COMMENT	RESPONSE
ENVIRONMENT PROTECTION AUTHORITY	
Noise	
<p>Predicted Impacts at Surrounding Receptors</p> <p>The New South Wales (NSW) Environment Protection Authority (EPA) submission included the following recommendations relating to the Noise and Blasting Assessment:</p> <ul style="list-style-type: none"> • That the proponent is required to utilise the Private Negotiated Agreement provisions of the NSW <i>Industrial Noise Policy</i> to address the predicted noise impacts at receptors 89b and 127b. • That the proponent is required to complete the commitment made in the <i>Vickery Coal Project Environmental Impact Statement</i> (the EIS) (page 4-59) that ...<i>Whitehaven is intending to enter into noise or purchase agreements with the owners of receivers 89b (and 89a), 127a, 127b and 127c...</i> to address the predicted noise impacts at receptors 89a, 127a and 127c. 	<p>Whitehaven Coal Limited (Whitehaven) notes the EPA's endorsement of efforts to seek noise or purchase agreements with the owners of properties 89 and 127. Since the EIS was exhibited in March-April 2013, Whitehaven has agreed to terms with the owner of property 89 and a legal agreement is being finalised. Whiteha

FIGURE 1-1 Vegetation Mapping and Photograph Locations

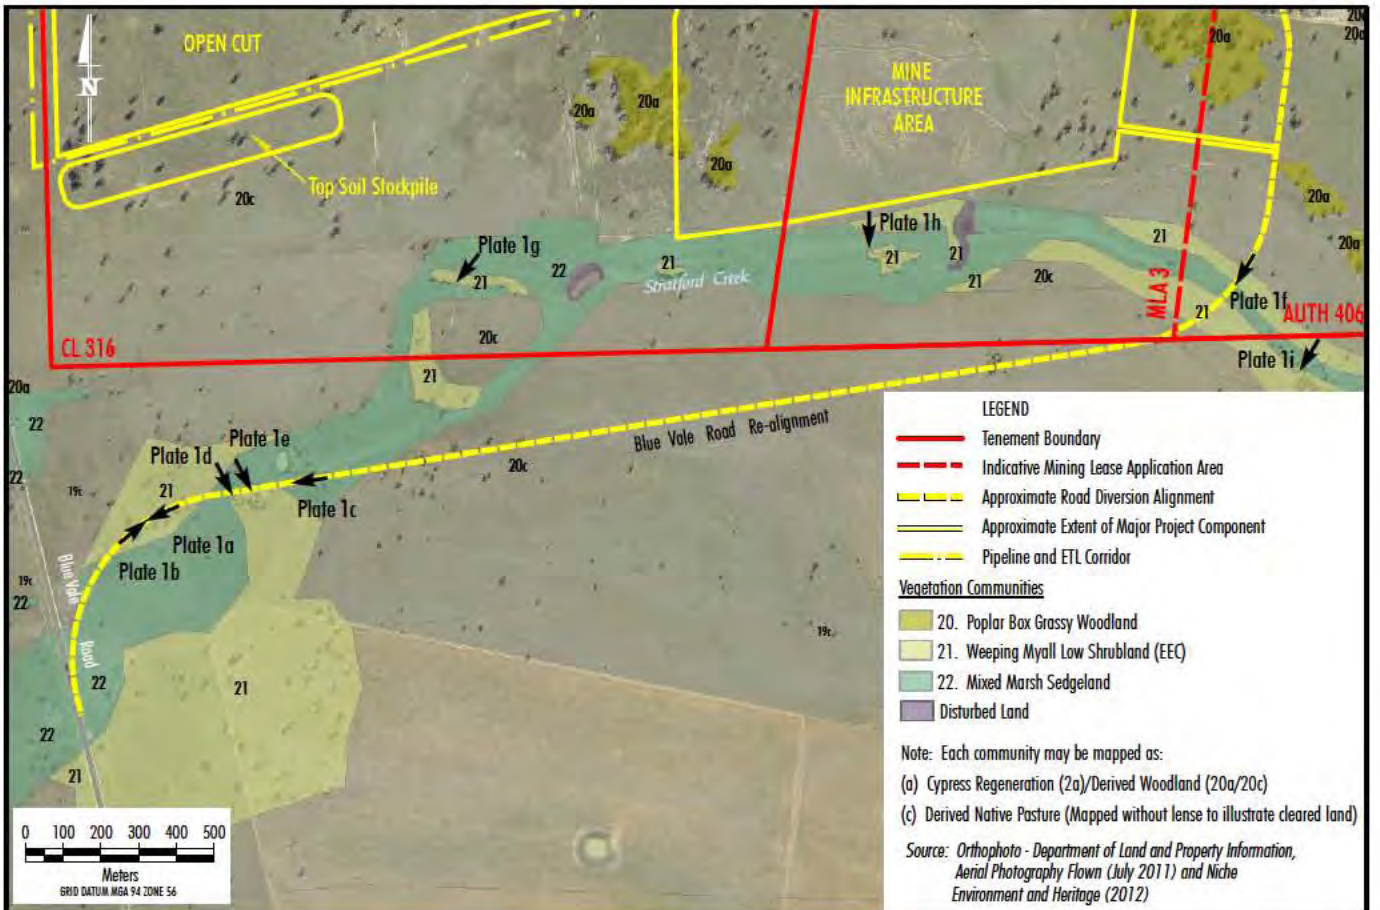
<p>Proposed Offset for the Weeping Myall Woodland Endangered Ecological Community</p> <p>The OEH submission noted that the version of the EIS reviewed by OEH for adequacy in December 2012 stated that only 22 hectares (ha) of the Weeping Myall Woodland Endangered Ecological Community (Weeping Myall Woodland EEC) remained within the locality and therefore the Project would be removing 4.8% of the community. The submission noted that in the version of the EIS prepared for public exhibition in March-April 2013 it states that <i>at least 140 ha of this EEC occurs</i> (refer to page 151 of the EIS) within 20 km of the Project and therefore 0.7% of the EEC would be removed. The OEH submission noted that no justification was provided in the EIS to indicate why these figures were altered.</p> <p>The OEH submission stated that it supports the Proponents proposal to fence and manage an existing remnant of the Weeping Myall Woodland EEC along Stratford Creek. However, it also noted that the Weeping Myall Woodland EEC is not offset within the Project biodiversity offset area at Willeroi East.</p>	<p>In the adequacy version of the EIS, the area of Weeping Myall Woodland EEC in the region was calculated from regional mapping within a 20 km radius from the mid-point between the Project mining area and the Private Haul Road and Highway Overpass (i.e. the centre of the two parts of the Project). For the exhibition version, the area of Weeping Myall Woodland EEC mapped in the region was calculated from regional mapping plus Project-specific mapping within a 20 km radius from the centre point of the Project mining area. This change was made to better focus on the region surrounding the mining area as it is where the Weeping Myall Woodland EEC was mapped by the Project surveys, as opposed to the private haul road and Kamilaroi Highway overpass where no Weeping Myall Woodland EEC would be disturbed. Regardless of the approach adopted, the area of Weeping Myall Woodland EEC that could be disturbed by the Project is very small (i.e. less than 1 ha).</p> <p>The proposed mitigation and management measures for the Weeping Myall Woodland EEC are described in Section 4.9.3 of the EIS and are as follows:</p> <ul style="list-style-type: none"> • Development and implementation of a program as part of the Biodiversity Management Plan to retain and manage the remaining vegetation along a portion of Stratford Creek, including the Weeping Myall Woodland EEC (refer to Figure 4-19 of the EIS). • Fencing of the perimeter of the area to be managed with a stock proof fence to facilitate regeneration of the native vegetation. • Management of weeds within the fenced area of Weeping Myall Woodland EEC. <p>The OEH submission indicated its support for the proposal to fence and manage these existing remnants.</p> <p>The OEH submission also noted that the proposed biodiversity offset area at Willeroi does not include the Weeping Myall Woodland EEC. Whitehaven acknowledges that this is the case, but believes that the proposed avoidance, management and regeneration strategies for this community are sufficient and appropriate to maintain biodiversity values in the region given the very small area of the Weeping Myall Woodland EEC that could be impacted by the Project. Further explanation and justification is provided below.</p>

COMMENT	RESPONSE
	<p>Avoidance of Weeping Myall Woodland EEC During the Detailed Design Phase</p> <p>The mapping of the Weeping Myall Woodland EEC presented in the EIS was conservative (i.e. areas of cleared farmland dispersed with isolated or small groups of Weeping Myall trees were included within the mapped extent of the EEC). As a result, the estimated 1 ha disturbance to the Weeping Myall Woodland EEC is considered to be a conservative maximum.</p> <p>In order to qualitatively illustrate this point, a series of photographs and figures are provided in Attachment A of this document (i.e. Plates 1a to 1i and Figures 1-1 to 1-3). The figures show the approximate route of the centre line of the proposed Blue Vale Road re-alignment in relation to individuals and clumps of Weeping Myall trees near the route. As illustrated by the photographs and figures, the centre line of the conceptual Blue Vale Road re-alignment is located within cleared paddocks with very limited tree cover and avoids individual trees and clumps of Weeping Myall.</p> <p>The final alignment of the Blue Vale Road re-alignment would be determined in consultation with the Gunnedah Shire Council (GSC) and the road would be designed in accordance with the Austroads design standards and relevant conditions of approval. Geotechnical and local flooding information would be considered in the design phase. Whitehaven would also conduct detailed mapping of the Weeping Myall in the vicinity of the route and would adjust the design to avoid disturbance to individual trees where possible. It is expected that by adopting this approach the actual quantity of Weeping Myall Woodland EEC that would be disturbed would be reduced further.</p> <p>Management and Regeneration of Weeping Myall Woodland EEC during Operations</p> <p>The areas of the Weeping Myall Woodland EEC located in the vicinity of the proposed Blue Vale Road re-alignment are currently unfenced. They have no mid-storey and a very sparse and degraded ground layer as a result of stock grazing (refer to Plates 1a to 1i in Attachment A). There is currently no or very little regeneration of Weeping Myall trees due to grazing, and in the long-term (i.e. if current agriculture were to continue) these trees are likely to degrade further and could ultimately be lost.</p> <p>As described in Section 4.9.3 of the EIS, Whitehaven would fence and manage remaining Weeping Myall vegetation along a portion of Stratford Creek. This would remove the current threats imposed by livestock grazing and weeds and would increase the probability of natural regeneration within the fenced area. The size and location of the fenced area would be determined in consultation with OEH and would be documented in the Biodiversity Management Plan.</p>

Kamilaroi Highway Overpass - Flood Level Increases at Nearby Dwellings

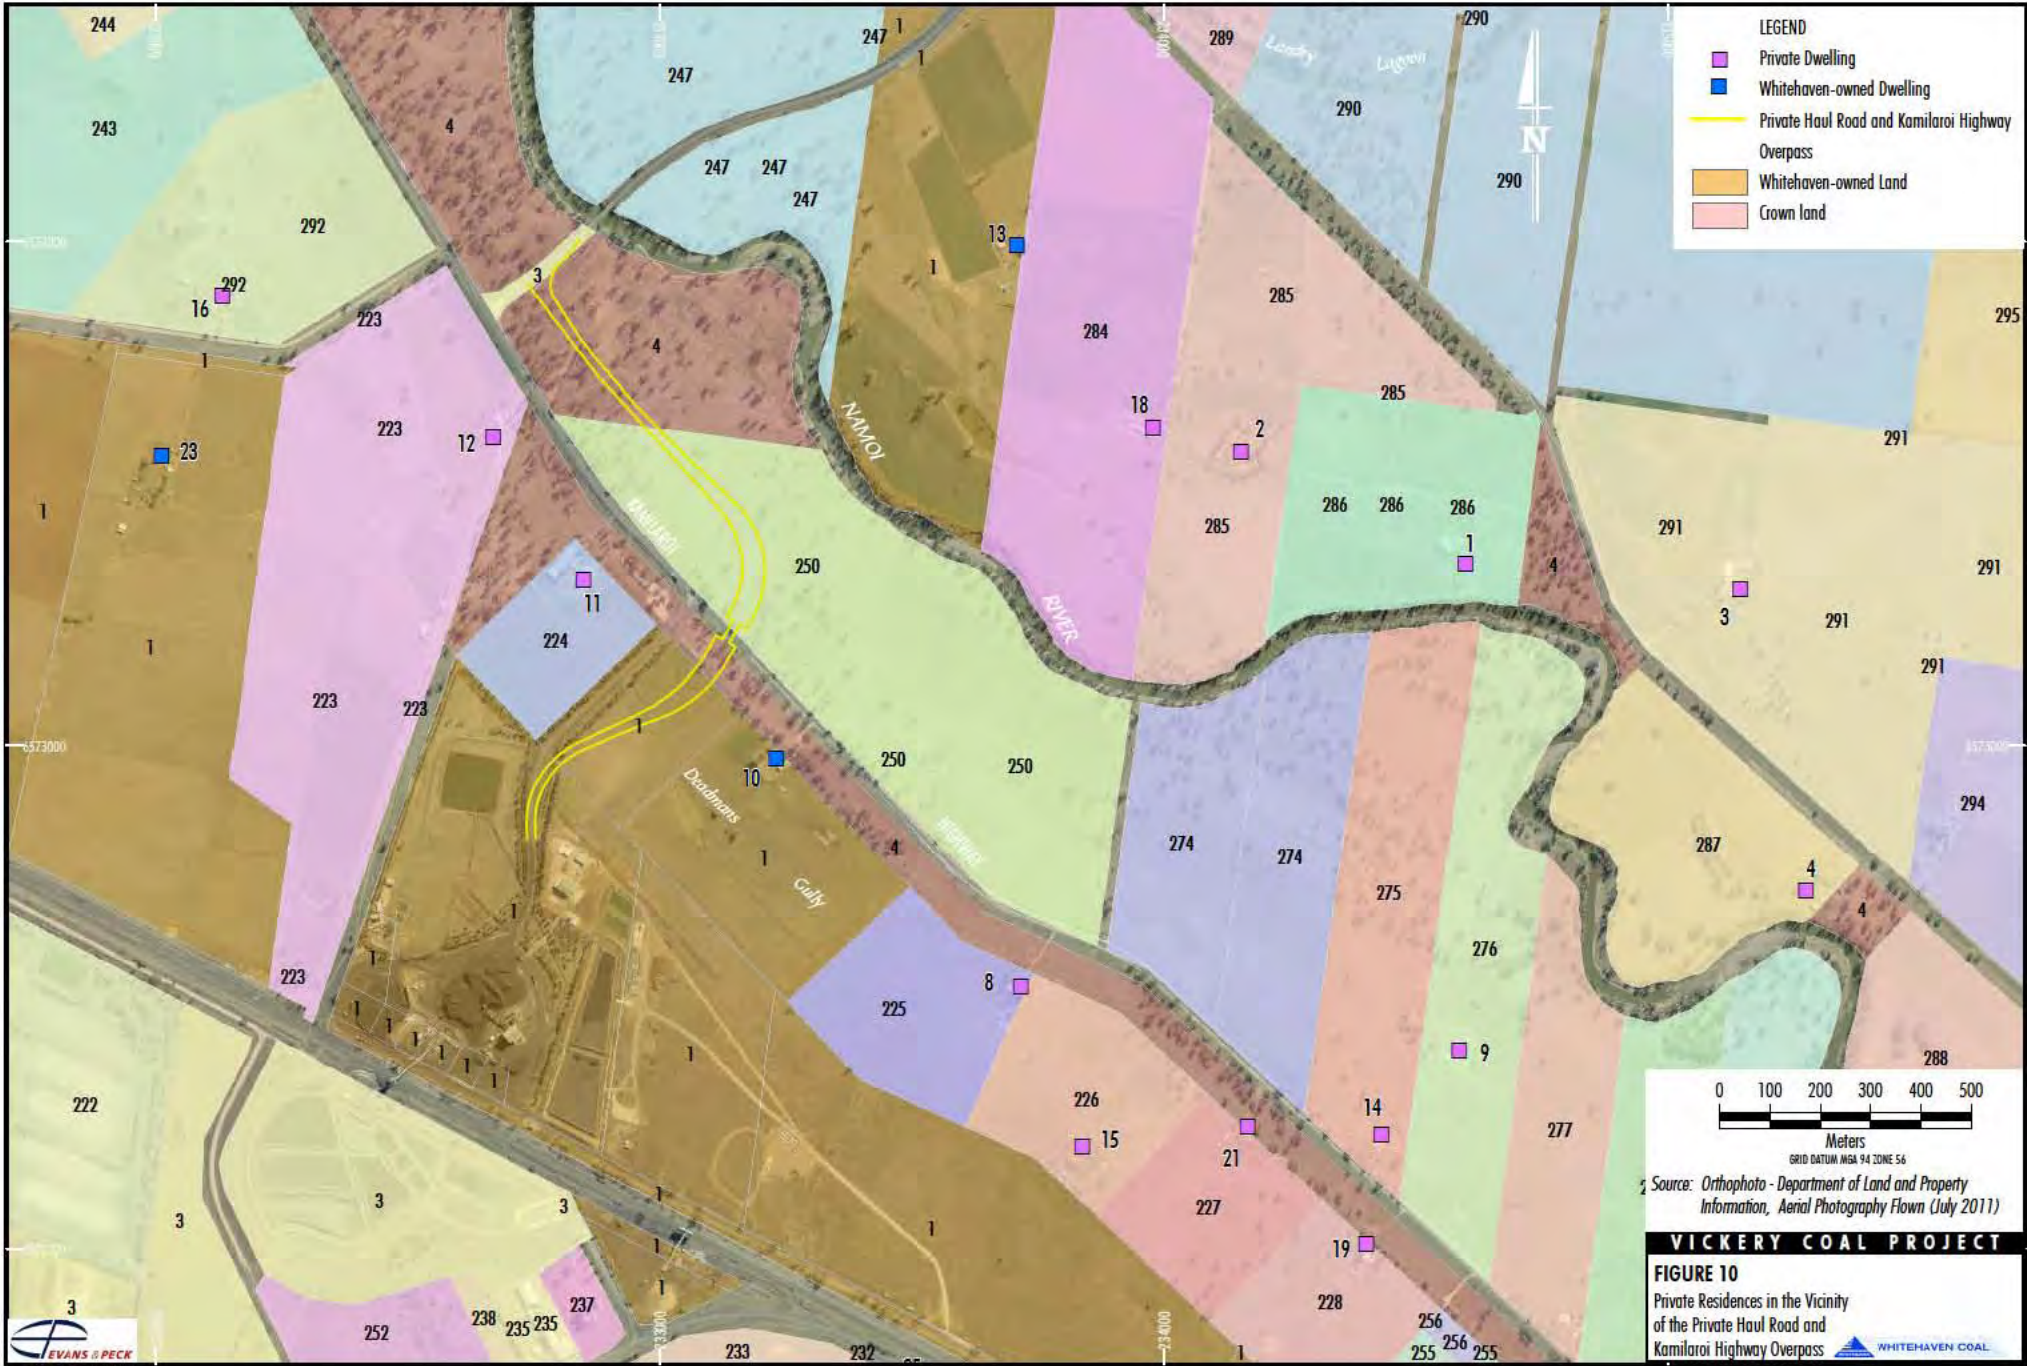
PUBLIC 6 – P. Rankin	
<p>The submission raised concerns regarding potential flooding impacts on their residence due to the proposed construction of the Kamilaroi Highway overpass.</p>	<p>The location of the relevant dwelling is shown on Figure 4-13 of the EIS (i.e. Private Dwelling #21). It is situated approximately 1.4 km upstream of the proposed Kamilaroi Highway overpass and is adjacent to the Kamilaroi Highway. A survey of the floor level at the front door of the residence was conducted in March 2013 and recorded a level of 261.90 m AHD. The residence is not surrounded by a flood bund.</p> <p>The predicted 1:100 flood level at this residence (without the proposed Kamilaroi Highway Overpass) is 262.25 m AHD. The flooding assessment conducted by Worley Parsons (Appendix B of the EIS) for the Project predicted that flood levels would increase by up to 3 cm at this location during a 1:100 flood event. The increase would be proportionally less during smaller flood events.</p> <p>In order to manage and minimise flooding impacts associated with the proposed Kamilaroi Highway Overpass, the detailed design would be prepared in consultation with RMS, GSC, NOW and the OEH Inland Flood Unit. The detailed design would include consideration of design details that would assist with further minimising flood impacts (e.g. culvert sizing and placement within the road infrastructure, height of the road above the surrounding topography, width of the gap where the overpass crosses the Kamilaroi Highway).</p> <p>Whitehaven would also include in the Project Water Management Plan a process for reviewing the predicted flood levels at private receivers once the detailed design of the private haul road and Kamilaroi Highway overpass is complete. Detailed survey of dwellings and any existing flood mitigation structures would be considered as part of this process to refine the predicted potential flooding impacts as a result of the construction of the private haul road and Kamilaroi Highway overpass.</p> <p>Should adverse changes in flooding impacts to privately-owned dwellings as a result of the construction of the private haul road and Kamilaroi Highway overpass be identified as part of this process, Whitehaven would develop and implement management measures in consultation with landholders to minimise potential flood impacts at the dwellings.</p>

COMMENT	RESPONSE
	<p>Flood Velocities</p> <p>Figures 6-1a and 6-1b in Attachment A of this document provide plans of the MIKE-11 model structure (from the existing flood analysis) around the proposed works. Tables 6-1a and 6-1-b in Attachment A provide the associated tabulated flow velocity results. These results demonstrate that the modelled flood velocity increases are compliant with this criterion: namely that increases in flood velocities are less than 50% and no greater than 0.5 metres per second. The detailed design of the overpass is expected to increase the conveyance capacity along Deadmans Gully and minimise any resulting change in velocity. The flow velocities will be verified once further flood modelling is undertaken at the time of detailed design.</p> <p>Distribution of Flows</p> <p>The results of the MIKE-11 model (from the interim flood analysis) show that the effect of the existing design would be to divert some flow from Deadmans Gully into the main Namoi River flow. The majority of modelled flow increases in the vicinity of the proposed works are between 2 and 7%. These results demonstrate that the modelled change in flow distribution is generally compliant with the criterion to limit cumulative redistribution of flows to be less than 10%. The detailed design of the overpass is expected to increase the conveyance capacity along Deadmans Gully and minimise any resulting change in flow redistribution. Further analysis will be undertaken at the time of detailed design in order to verify the impact of the design on flow redistribution.</p> <p>Flood Levels at Property Boundaries</p> <p>Figure 6-2 in Attachment A of this document is a figure showing property boundaries in the vicinity of the proposed private haul road and Kamilaroi Highway overpass with changes in flood levels at the most affected point of each property boundary based on the result of the existing MIKE-11 model. All increases to flood levels at these points comply with the criterion to limit flood level increases to less than 100 millimetres (mm). The detailed design of the overpass is expected to increase the conveyance capacity along Deadmans Gully and minimise any resulting change in flood levels at property boundaries. The flood level increases will be verified once further flood analyses are conducted at the time of detailed design.</p> <p>Flood Levels at Dwellings</p> <p>Table 17 in Appendix B of the EIS provided details of modelled flood level increases at various dwelling in the vicinity of the proposed overpass, which are reproduced in Table 6-2 in Attachment A of this document. The dwelling numbers in the first column identify each dwelling on the plan in Figure 6-2 in Attachment A of this document. The maximum flood level increases (80 to 90 mm) occur at dwellings owned by Whitehaven. As part of the detailed design process for the overpass, the modelled flood level at each dwelling will be re-assessed together with an assessment of the significance of any flood level increase on the available freeboard between the design flood level and the floor level of each potentially affected dwelling, or lowest level on a levee surrounding the property.</p>

VICKERY COAL PROJECT
FIGURE 7-1
 Road Network in the Vicinity of
 Shannon Harbour Road

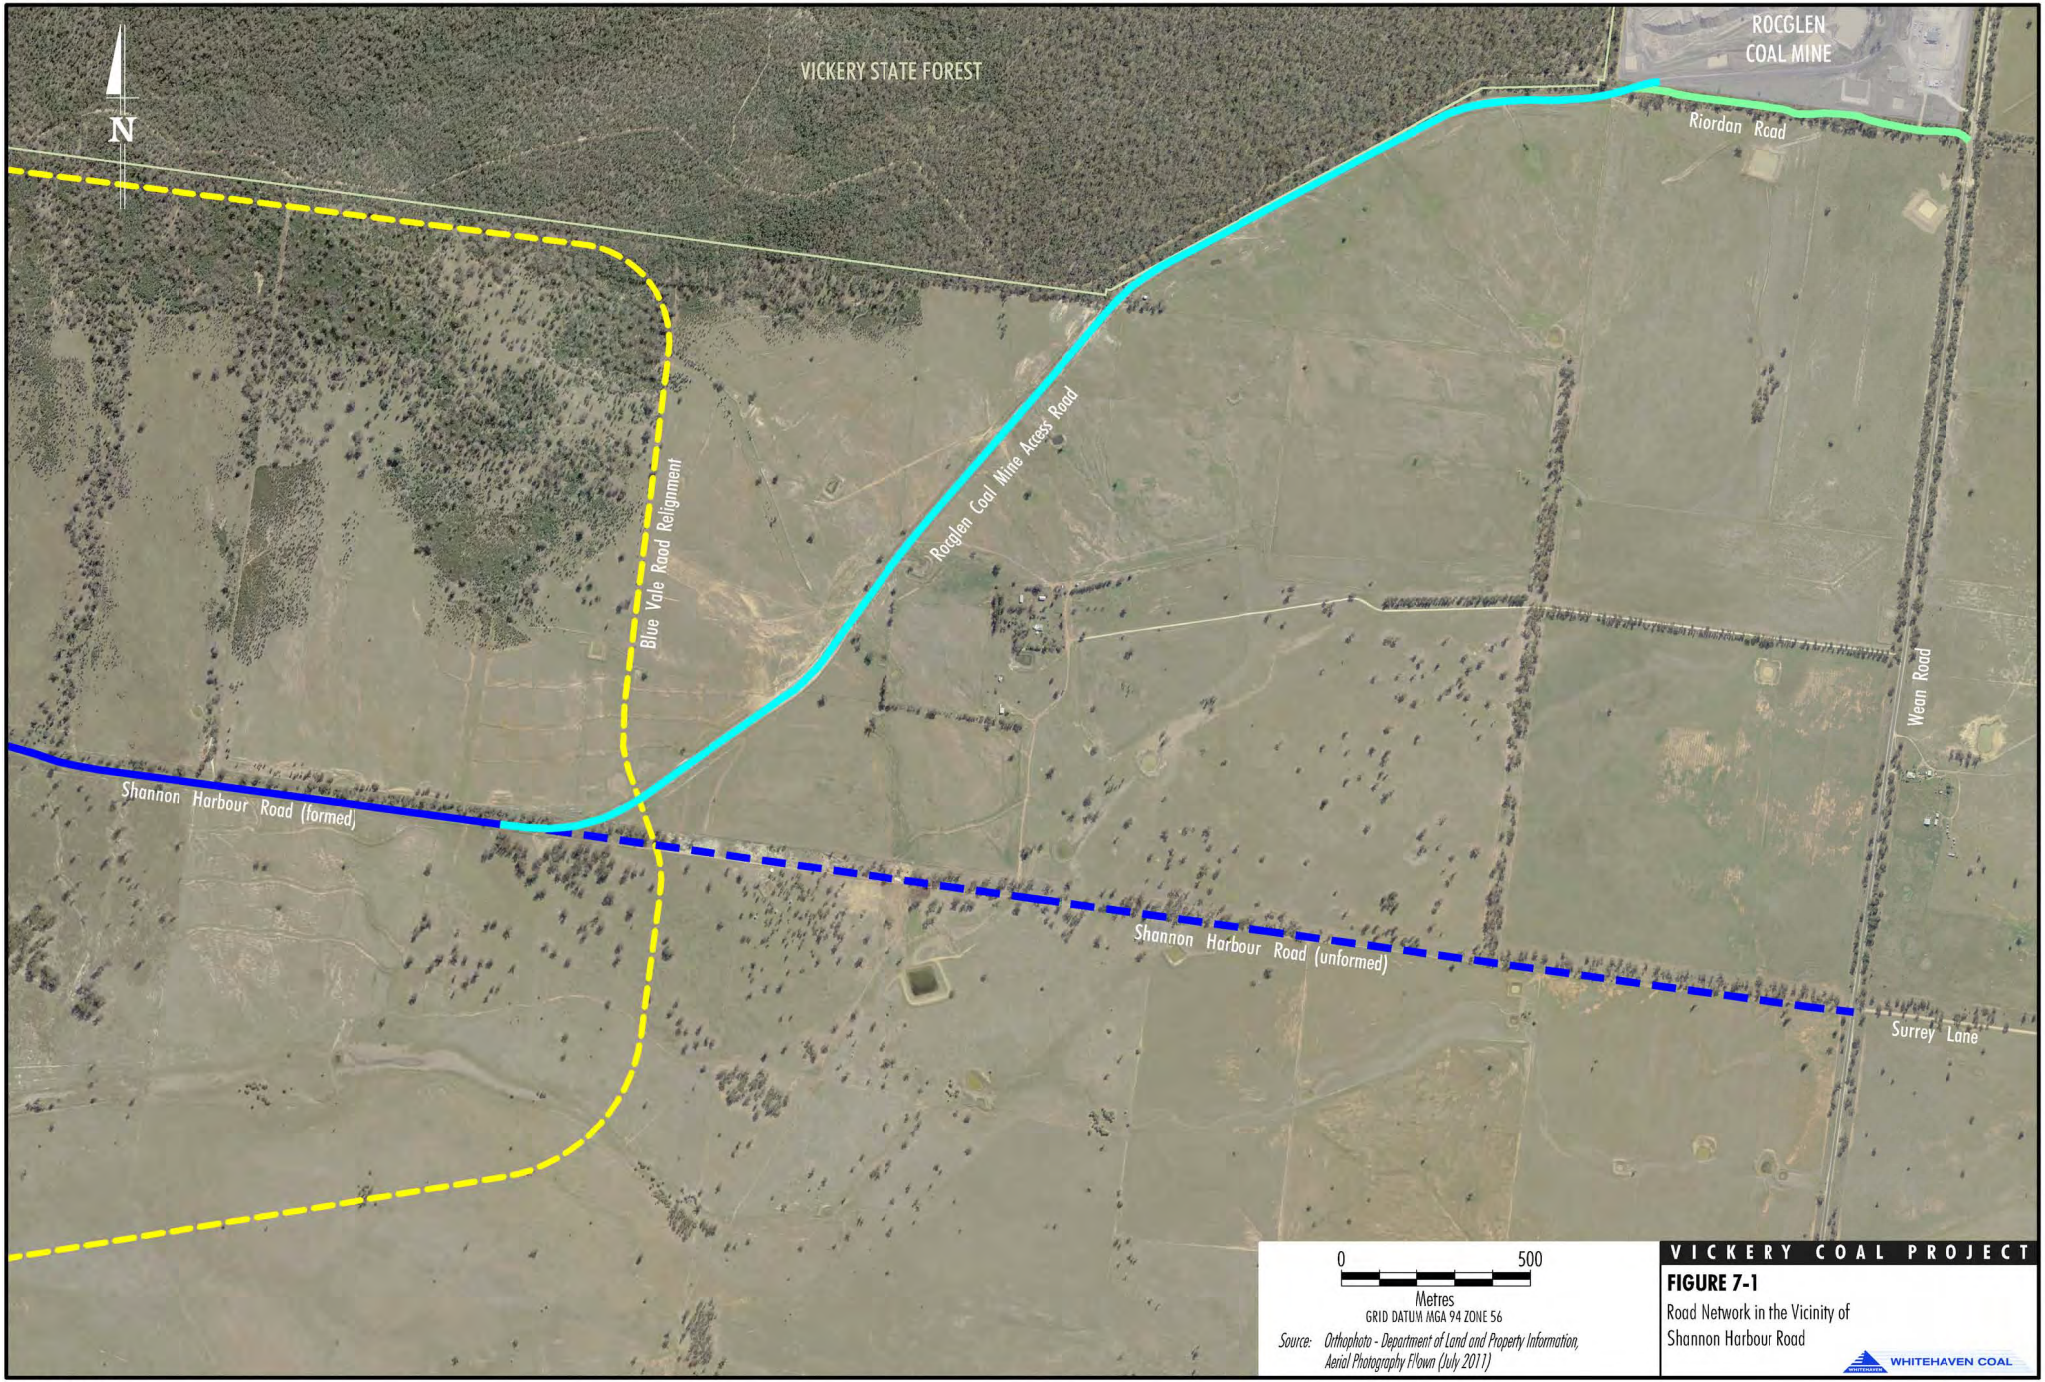
COMMENT	RESPONSE
	<p>Notwithstanding, Whitehaven supports GSC's desire to close Shannon Harbour Road over its entire length and to dedicate the Rocglen Coal Mine Private Haul Road as a public road.</p> <p>As discussed in Section 2.4.1 of the EIS, Whitehaven would determine the preferred access arrangement for vehicles travelling from Wean Road to the Rocglen Coal Mine Access Road during the first year of the Project (with access via Riordan Road or through the Rocglen Coal Mine infrastructure area). The number of movements between these roads during the first year of the Project is anticipated to be only 23 movements per day. If Riordan Road is determined to be the preferred route to the Project mining area from the east, Whitehaven commits to upgrading the road to a suitable Austroad standard in consultation with the GSC.</p>
<p>Blue Vale Road Realignment</p> <p>The GSC submission stated that the general realignment of Blue Vale Road is considered to be acceptable to the Council subject to specific treatments on intersection and road design associated with the realignment. The GSC submission also included the following recommendations:</p> <ol style="list-style-type: none"> 1. That the intersection of Old Blue Vale Road and realigned Blue Vale Road shall be designed to Austroad design standards subject to Council approval. 2. That all bends on the realigned Blue Vale Road shall be constructed to a 100 kilometres per hour (km/hr) design and be subject to Council approval. 	<p>The GSC is referring to the point where the Blue Vale Road realignment would connect to the existing Blue Vale Road. An intersection would be constructed to the Austroad standard applicable to the category and predicted usage of the road in consultation with GSC, and approval would be sought in accordance with Section 138 of the NSW <i>Roads Act, 1993</i>. It is understood that authorisation for construction of the works in accordance with Section 138 of the <i>Roads Act, 1993</i> are to be substantially consistent with the Part 4.1 Development Consent.</p> <p>The Blue Vale Road realignment would be designed to allow for a speed limit of 100 km/hr, consistent with the existing speed limit of Blue Vale Road. It is noted, however, that the recommended speed limits for corners may be less than 100 km/hr to ensure safety and in consideration of heavy vehicle traffic movements.</p>
